# JENSAMP-51X

rev02 schematic

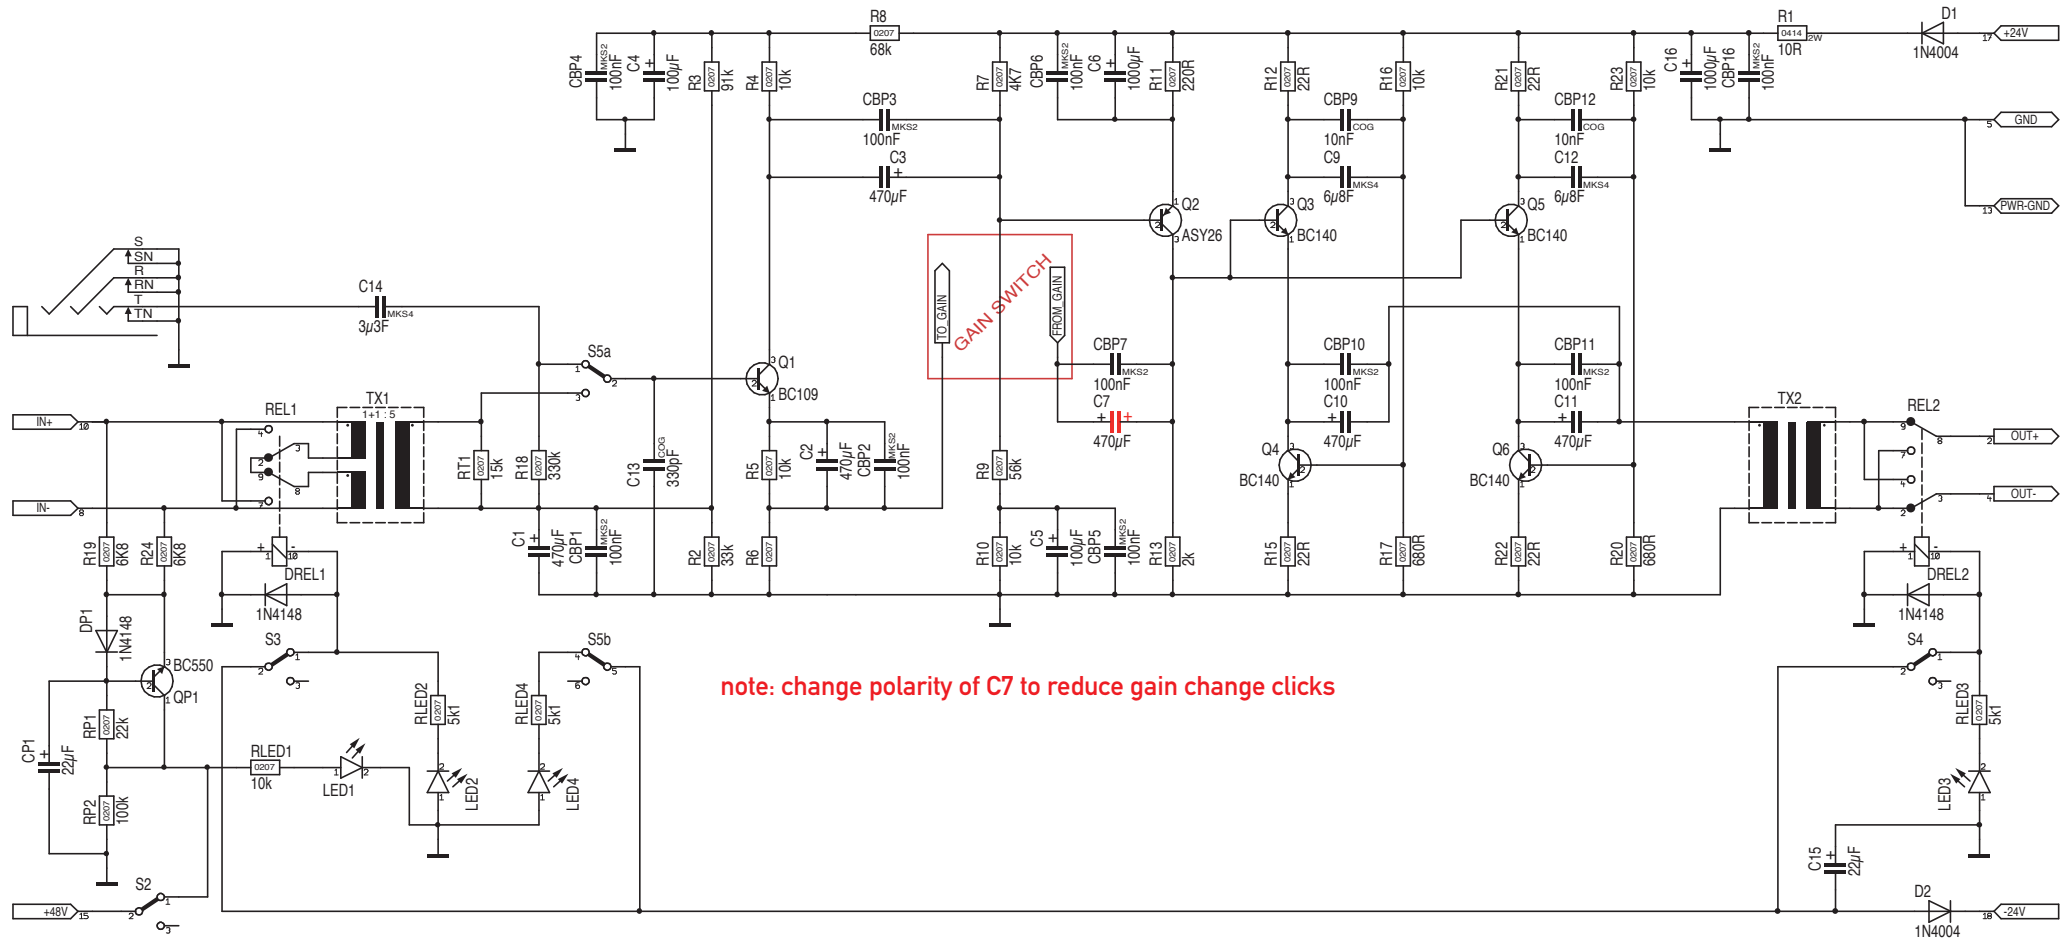
note: change polarity of C7 to reduce gain change clicks
